# Access Compliance Report

## Public Rights-of-Way

Intersection ID: 14754	Main Street: SOUTH_BV	Cross Street: IVERSON_WY	Location: S
ADA ID: D79DA5124D29	Ramp Type: Perp	Initial Pass/Fail: Fail	Overall Compliance: No
			Severity Score: 13.75

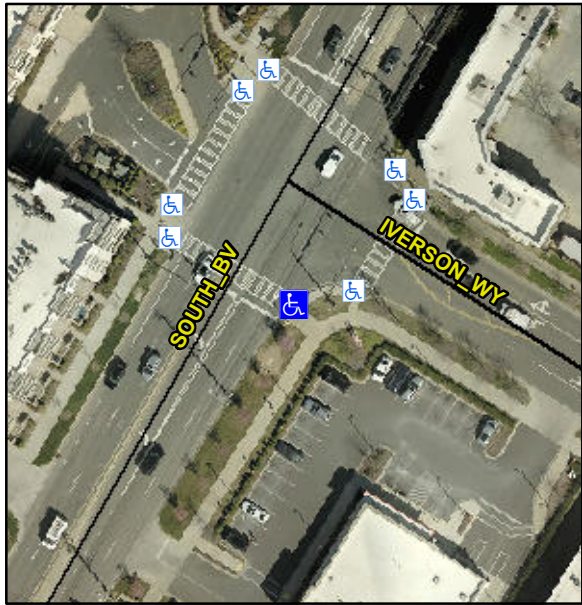
Codes/Mitigation Info/Possible Solution			Field Measurements/Component Compliance					
	Possible Solutions:		Compliance	Description	Data	Compliance	Description	Data
	Remove & Replace Entire Ramp.		N/A	Ramp Length (in)	49.0	No	Ramp Slope (%)	9.1
			Yes	Ramp Width (in)	48.0	No	Ramp XSlope (%)	4.5
			N/A	Flare Type LT	N/A	N/A	Flare Type RT	N/A
			N/A	Flare Slope LT (%)	N/A	N/A	Flare Slope RT (%)	N/A
			N/A	Flare Traversable LT?	N/A	N/A	Flare Traversable RT?	N/A
			N/A	Landing Length (in)	N/A	N/A	DWS Provided?	N/A
			N/A	Landing Width (in)	N/A	N/A	DWS Contrast?	N/A
			N/A	Landing Slope (%)	N/A	N/A	DWS Length (in)	N/A
			N/A	Landing X Slope (%)	N/A	N/A	DWS Full Width?	N/A
Surveyor Notes:			N/A	Landing Curb? (Y/N)	N/A	N/A	DWS Offset (in)	N/A
PROW/ADA:			N/A	Shared Landing?	N/A			
Not Found, R304.2.2, R304.5.3			N/A	Gutter Ponding?	N/A	N/A	Gutter Slope (%)	N/A
			N/A	Gutter Lip Ht (in)	N/A	N/A	Gutter X Slope (%)	N/A
